Southern California Edison
WODUP A.13-10-020

DATA REQUEST SET A.13-10-020 WODUP ED-SCE-10

Preliminary Corridor Cross-Section (Segment 4) – 550 kV Structures Replacing 220 kV

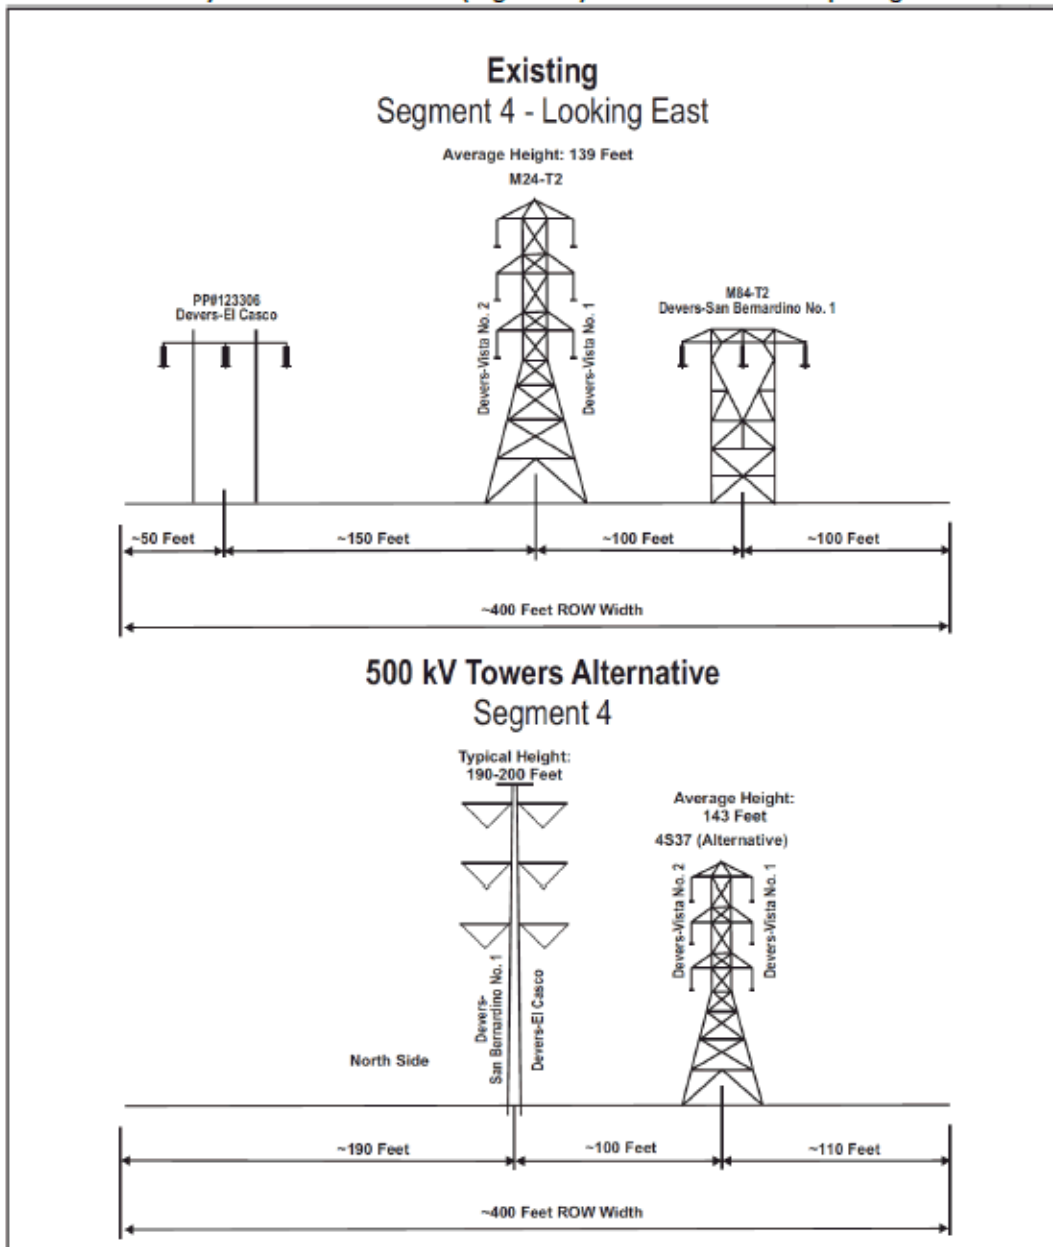
Given the general description of the configuration of 220 kV and 500 kV structures shown in the figure on the following page, please answer the following questions:

(D) What potential schedule delays could result from this design configuration? If delays could be longer than the 12 months addressed in ALT-17(E), please describe the specific consequences of the delay. What specific known projects would be affected in terms of their deliverability?

While SCE has not conducted a rigorous analysis to assess the schedule impacts for the use of 500 kV structures and does not have sufficient detail to understand the full scope of the proposal for the 500 kV alternative being proposed by the CPUC, SCE assumes that a redesign of the northern set of structures from 220 kV to 500 kV and associated access/stub roads, construction areas and site specific grading would be required. Additionally, construction duration would

increase due to the use of the larger 500 kV structures. Without further detail regarding the scope of the proposal for the 500 kV alternative, it is reasonable to expect that schedule delays would be approximately 6-12 months greater than the 12-month delays previously described for an alternative that places new 220 kV structures in essentially the same location as the existing double circuit structures along the length of the Proposed Project (i.e., as described in SCE's response to Question No. ALT-15.A).

Regarding the consequences of a further delay and the specific projects that would be affected, please see SCE's response to Question No. ALT-17d.
